MEMORANDUM

MFG PROJECT: 180734

TO: Dr. A. K. Ibrahim, U.S. Nuclear Regulatory Commission
FROM: Roslyn Stern, Clint Strachan
DATE: December 21, 2004
SUBJECT: Sequoyah Fuels Corporation Site, Seismicity Issues
COPY: Craig Harlin, Sequoyah Fuels Corporation

FIGURE 1
 Magnitude-Frequency Curve
 Ozark Uplift

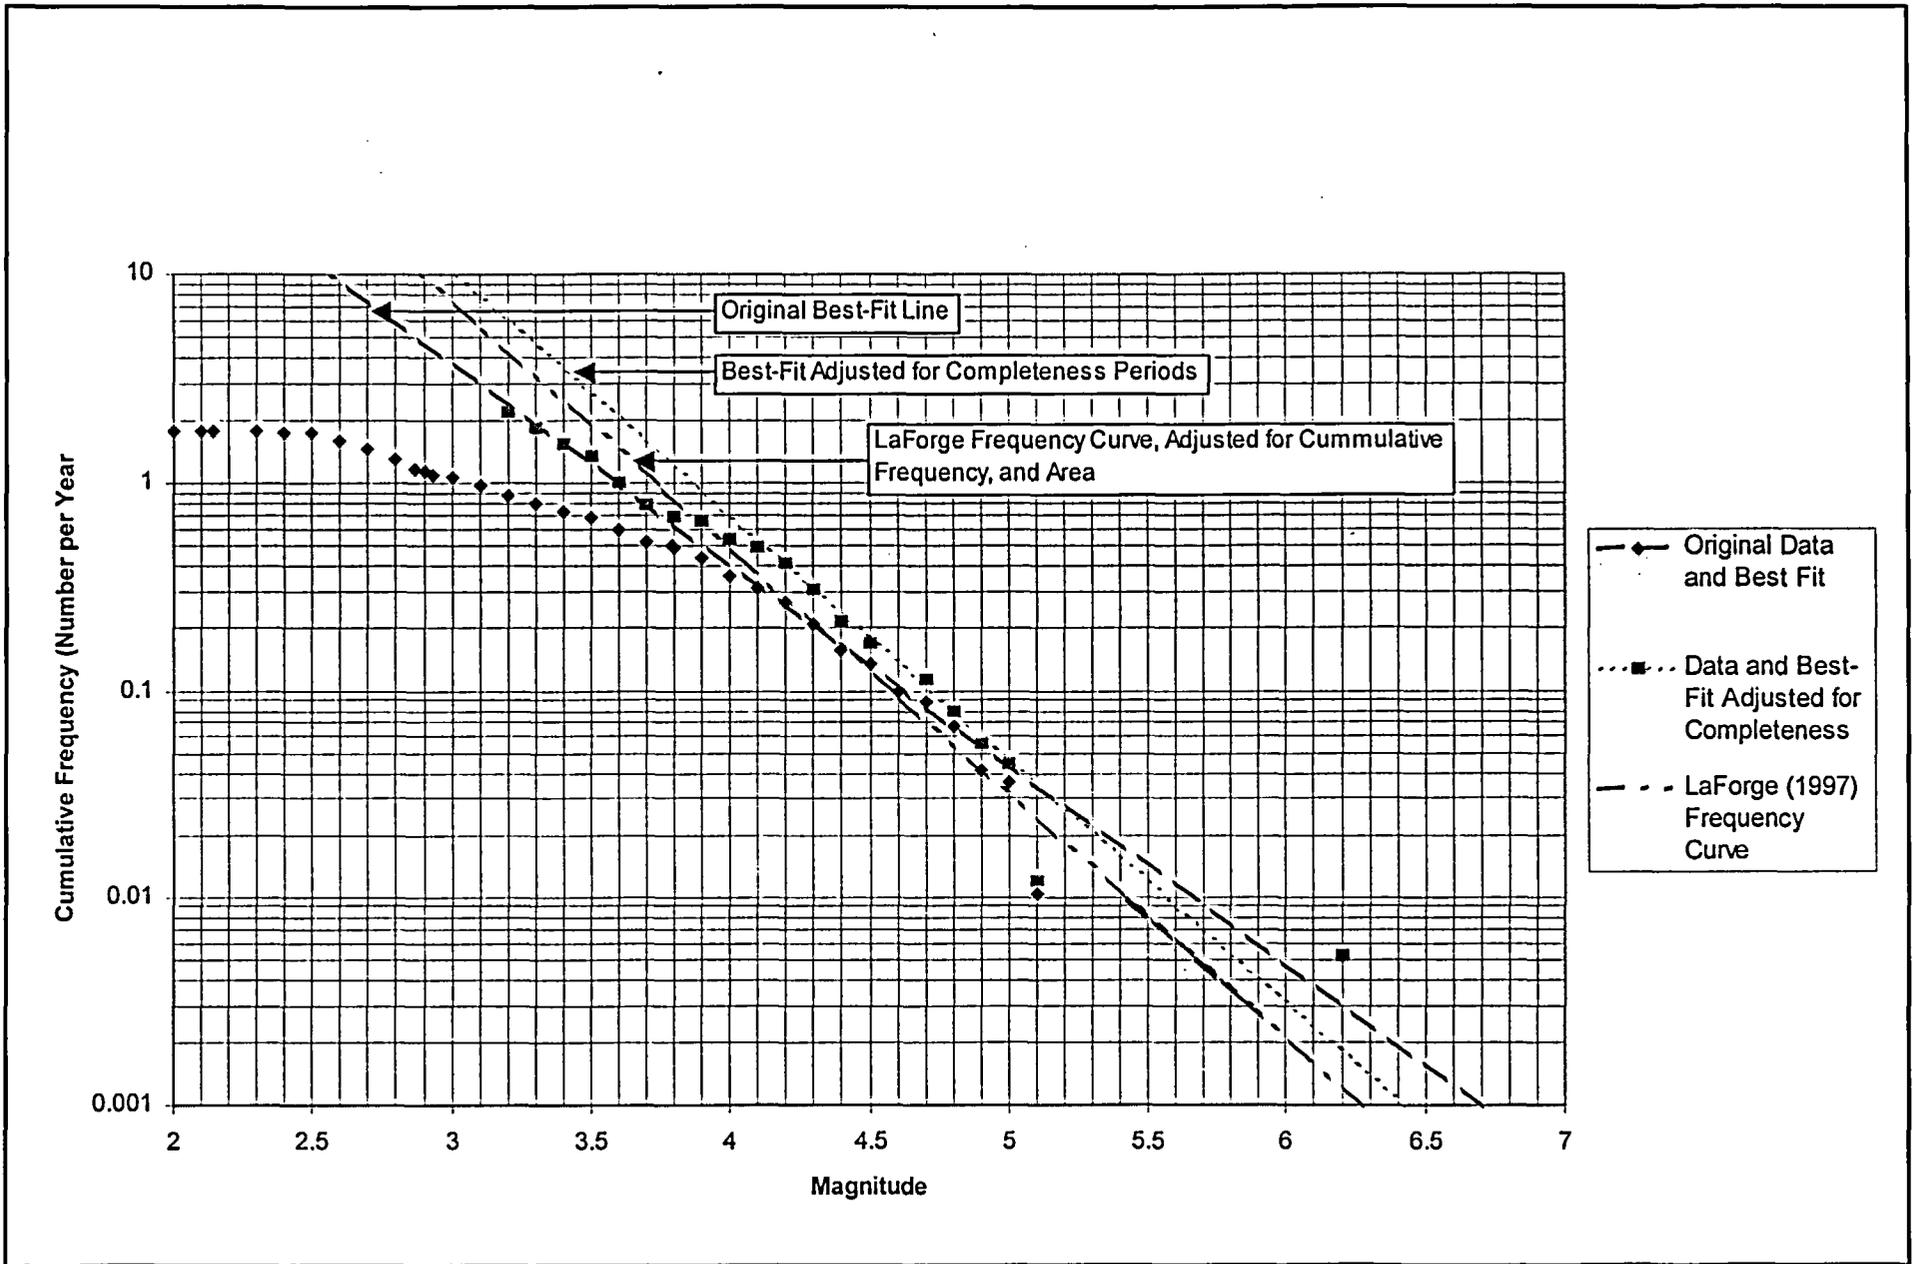
4. Assuming the random earthquake events can be limited to a magnitude of 6.2, what is the calculated peak horizontal acceleration if this event is applied 15 km from the site?

Using Atkinson and Boore (1995) attenuation equations, the computed horizontal acceleration is 0.46 g. Using the original magnitude-frequency curve as shown in Figure 1, the annual probability of having an event of this size occur within this distance is approximately 1/75,000. If the magnitude-frequency curve from LaForge (1997) is used (discussed further in comment 5), the annual probability of occurrence is 1/900,000.

- LaForge used a more rigorous technique to develop the recurrence interval of seismic events. This included correcting for completeness record and declustering dependent events. Figure 1 shows the original magnitude frequency curve developed by MFG, a revised MFG curve corrected for completeness record, and the curve developed by LaForge for Zone 3. It should be noted that LaForge's curve has been modified as presented in LaForge (1997) to represent cumulative frequency, rather than incremental, and adjusted for an equivalent area of the Ozark Uplift. The LaForge and MFG revised curves are similar, especially when considering that the source zones are slightly different (eastern Oklahoma of 65,000 km² versus the Ozark Uplift of 322,000 km²).

Figure 2. Mean hazard curves for PHA, McGee Creek Dam

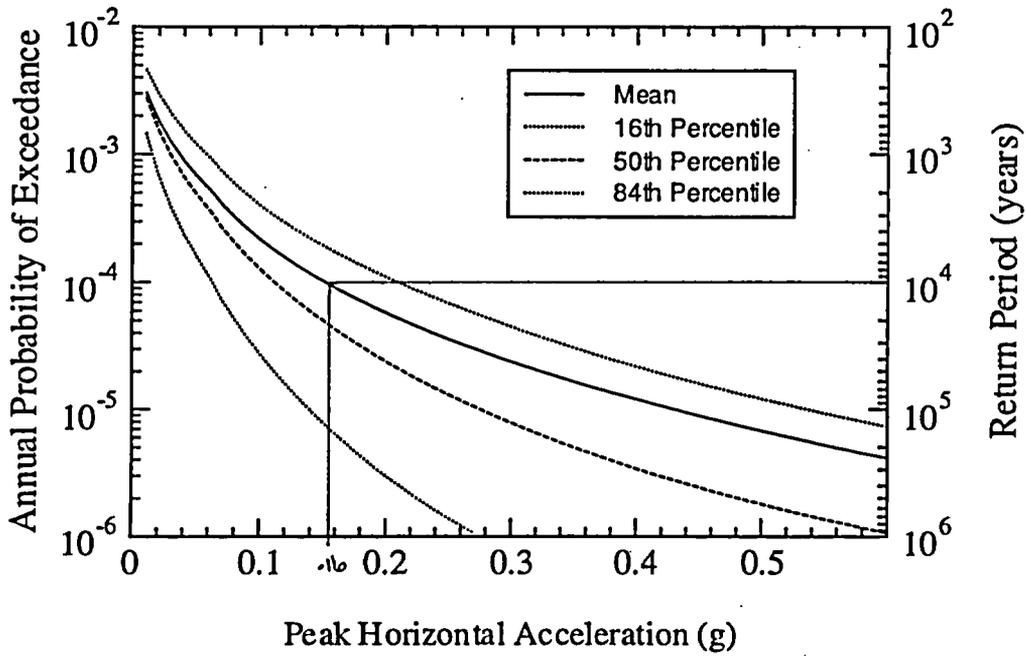
5. Dr. Ibrahim commented that he didn't feel comfortable with the explanation of using concentric circles about the site as source zones for the random earthquake analysis, and didn't agree with the larger circles (i.e. source zones) having larger 10,000-year earthquake events associated with them as presented in Tables 1 and 3 of the September 7, 2004 letter. Provide additional documentation to support technique and results for the random earthquake analysis.

As shown in the attached figure (Figure 2, draft report dated 10/5/04, shown in Attachment 2), the peak horizontal acceleration associated with the mean percentile, 1E-4 annual probability of exceedance is 0.16g.
